PORT MACQUARIE-HASTINGS
COUNCIL

Development Assessment Panel

Business Paper

Item: 05**Subject: DA2018 - 988.1 STAGED TORRENS TITLE SUBDIVISION AND MULTI DWELLING HOUSING WITH STRATA TITLE SUBDIVISION AT LOT 100 DP 1009007, NO. 16 OCEAN STREET, PORT MACQUARIE****Report Author: Development Assessment Planner, Benjamin Roberts**

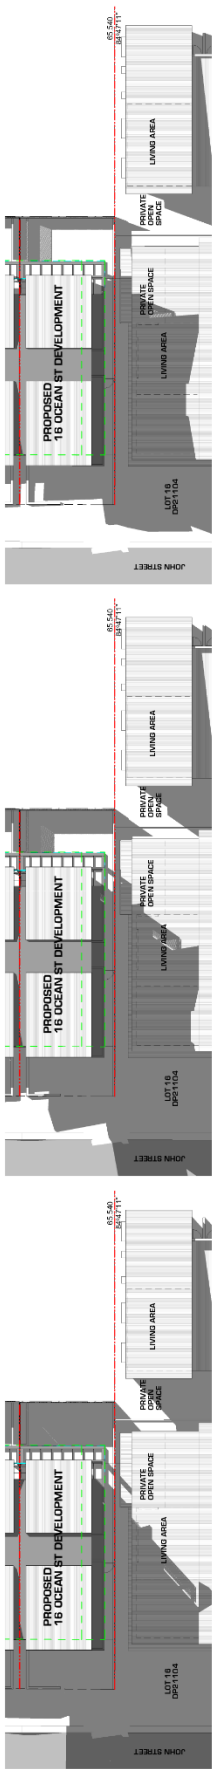
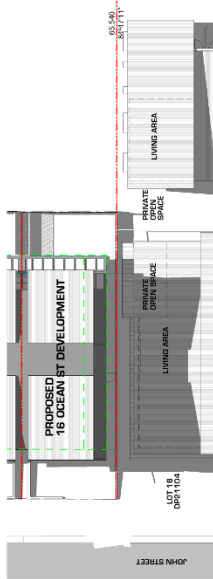
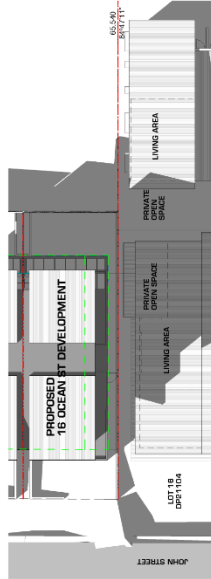
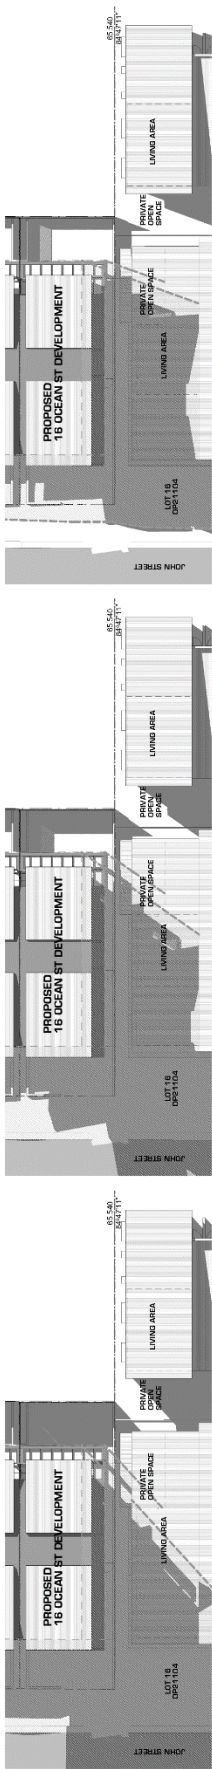
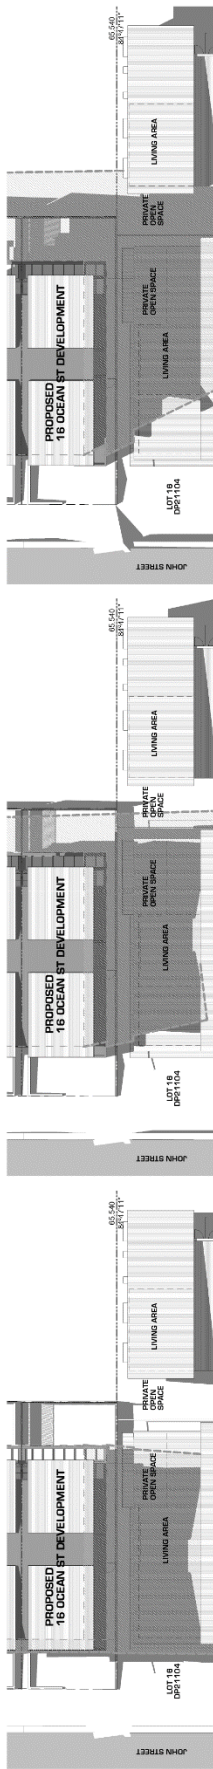
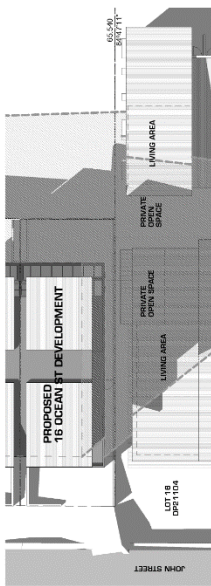
The 'planning principle' established in *Benevolent Society v Waverly Council* [2010] NSWLEC 1082 provides some key principles for consideration in establishing adequacy of solar access. The 'planning principle' is provided in the following terms:

Having regard to the above, the overshadowing impacts of the proposed development are considered to be adverse but do not warrant refusal of the application. This conclusion is based on the following key observations and established planning principle:

- The development site contains planning controls to which encourage higher density development. Notably an 11.5m maximum building height and 1.50:1 maximum floor space control. The claim to retain existing sunlight to the minimum standards for mid-winter is difficult to achieve.

APPENDIX A

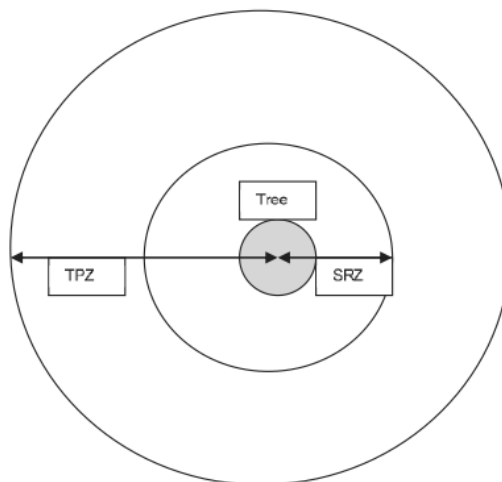
Any Development on this
block will damage tree.

Remove and compensatory
replant.

- The proponent has proposed two offset Swamp Mahogany plantings to the east of the development site within the same allotment.
- In this instance allowing removal of the tree with provision of two advanced sized offset plantings of the same species on the eastern part of the site is considered a satisfactory outcome.

- (20) The building Construction Certificate plans shall clearly nominate the location of two advanced sized compensatory Koala food trees (species being Swamp Mahogany) meeting NATSPEC standards. The plantings shall be well clear of any sewer infrastructure located within or adjoining the lot and have regard to the requirement of maintaining the site as an inner protection zone (IPA) in locating these plantings. Details to be provided to the satisfaction of the certifying authority prior to release of the building Construction Certificate.
